**2007 No. 311**

**The Traffic Signs (Amendment) Regulations  
(Northern Ireland) 2007**

## 639.1A

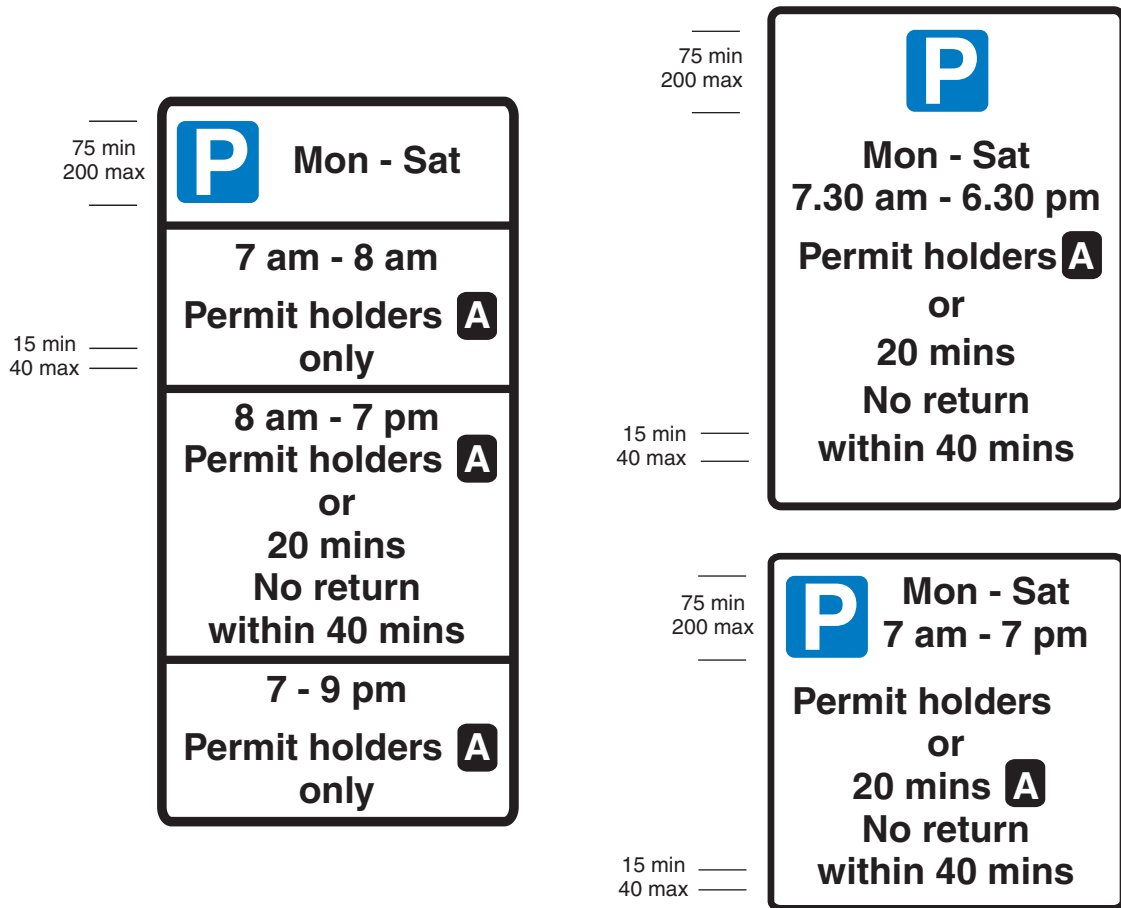
(a) for diagram 639.1A and the words specified in and under it there shall be substituted the diagram and the words specified in and under it specified in Part I of the Schedule;

Waiting prohibited during the periods indicated on the upper panel and restrictions on waiting during the period indicated on the lower panel

Item	
1	Regulations: None
2	Diagrams: 661.4, 857.1, 1017, 1019, 1028.3, 1028.4, 1032, 1033
3	Permitted variants: Schedule 16, items 11, 21, 22 “URBAN CLEARWAY” may be varied to “BUS LANE” or omitted. The relative positions of the “no waiting” symbol and other legend in the upper panel may be as shown in diagram 639 or in the upper panel of diagram 640. The upper panel may be varied to diagram 650.2. The lower panel may be varied in a similar manner to diagram 661.1, or varied to diagram 660, 660.3, 660.4, 660.5, 660.6, 660.7, 661.2, 661.3, 661A or 662. The sign shown in diagram 638.1 may be added as a middle panel with the size of the legend as shown for diagram 639.1A. A code letter or letters, as shown in diagram 660.3, may be added and may be varied in the same way as indicated in item 3 of the table below that diagram
4	Illumination requirements: Schedule 17, item 2

660.6

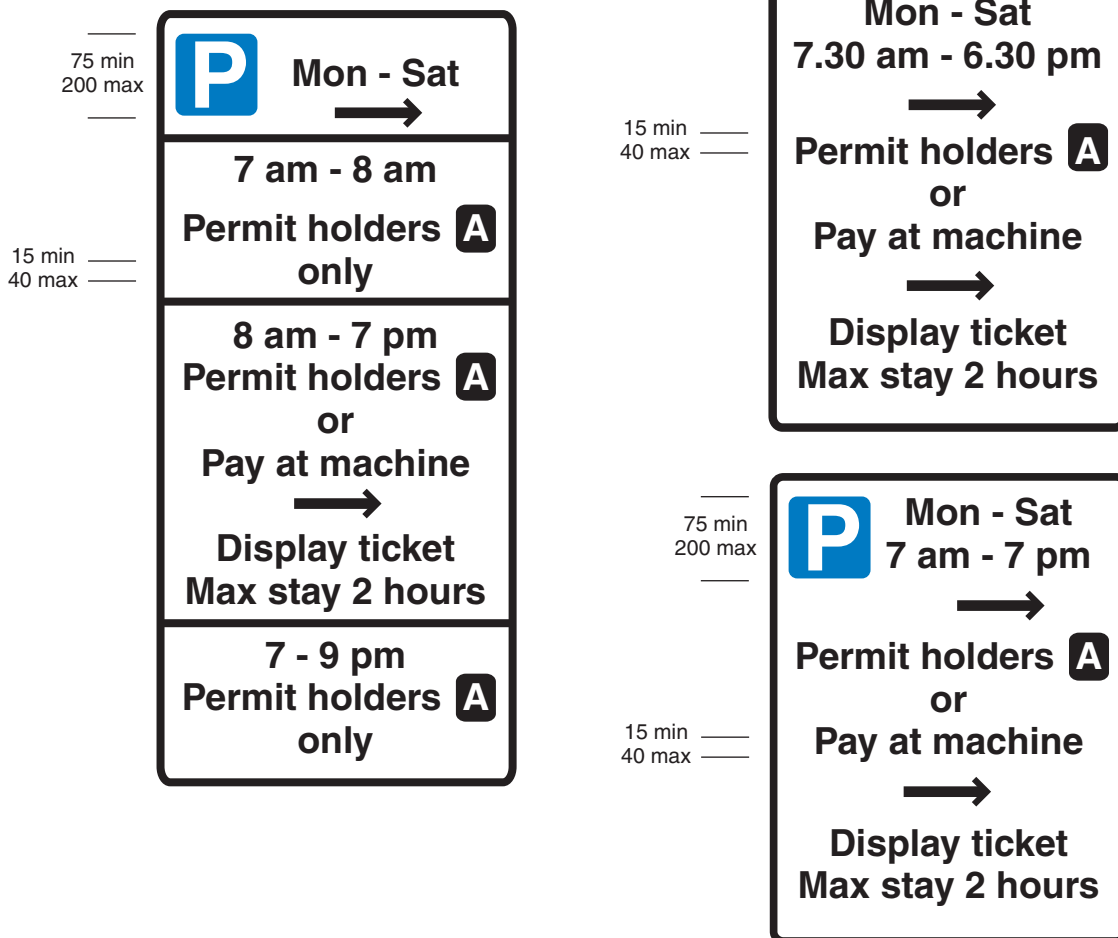
- (f) for diagrams 660.6 and 660.7 and the words specified in and under them there shall be substituted the diagrams and the words specified in and under them specified in Part II of the Schedule;

Parking place for permit holders with limited waiting permitted by others at specified times  
(Alternative types)

Item	
1	Regulations: None
2	Diagrams: 1028.4, 1032, 1033
3	Permitted variants: Schedule 16, items 11, 21, 22 "Permit holders" may be varied to "Resident permit holders", "Business permit holders", "Doctor permit holders", "Card holders" or "Resident permit holder parking only past this point". The number of panels in the left hand diagram may be varied. Each panel in the left hand diagram, other than the top panel, shall be in the form shown in the second or third panels from the top. In the third panel from the top, the legend "Permit holders A or" may be omitted. Where the "P" symbol only is shown in the top panel of the left hand diagram, it shall be centred horizontally on the sign. A code letter or letters, as shown in diagram 660.3, may be added and may be varied in the same way as indicated in item 3 of the table below that diagram
4	Illumination requirements: Schedule 17, item 2

670.3

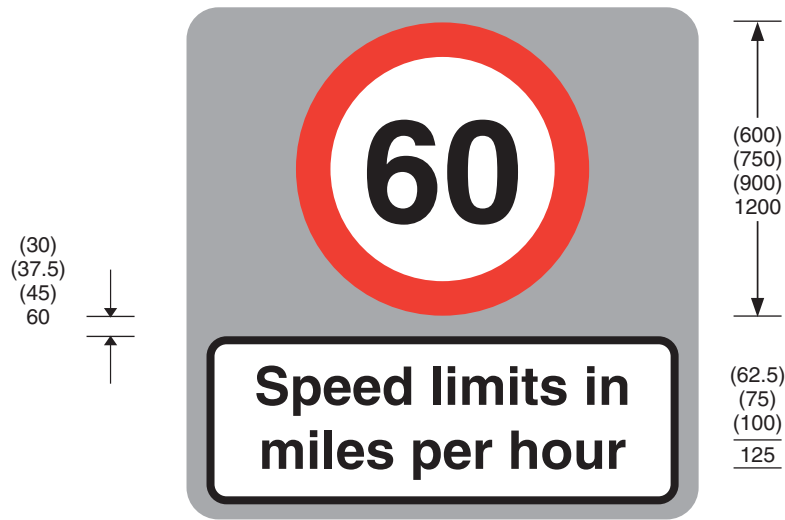
- (o) after diagram 670.2 there shall be inserted the diagram and the words specified in and under it specified in Part III of the Schedule.
- (4) In Schedule 4 (other informatory signs)—

Maximum speed limit and reminder to drivers that speed limits are in miles per hour

Item	
1	Regulations: None
2	Diagrams: None
3	Permitted variants: Schedule 16, item 1
4	Illumination requirements: Schedule 17, item 1

879.1

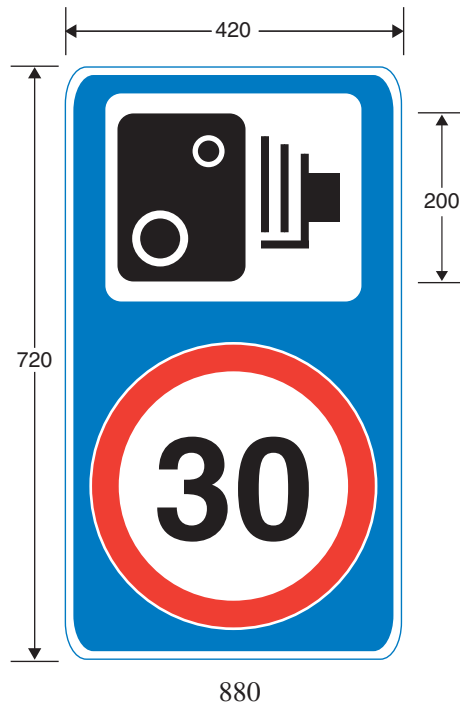
- (c) in diagram 879 in item 2 of the table after the words “878” there shall be inserted “ , 879.1”;
  - and
  - (d) after diagram 879 there shall be inserted the diagrams and the words specified in and under them specified in Part IV of the Schedule.

Average speed enforcement area

Item	
1	Regulations: None
2	Diagrams: 878 (when varied to "Speed cameras"), 879
3	Permitted variants: None
4	Illumination requirements: Schedule 17, item 1
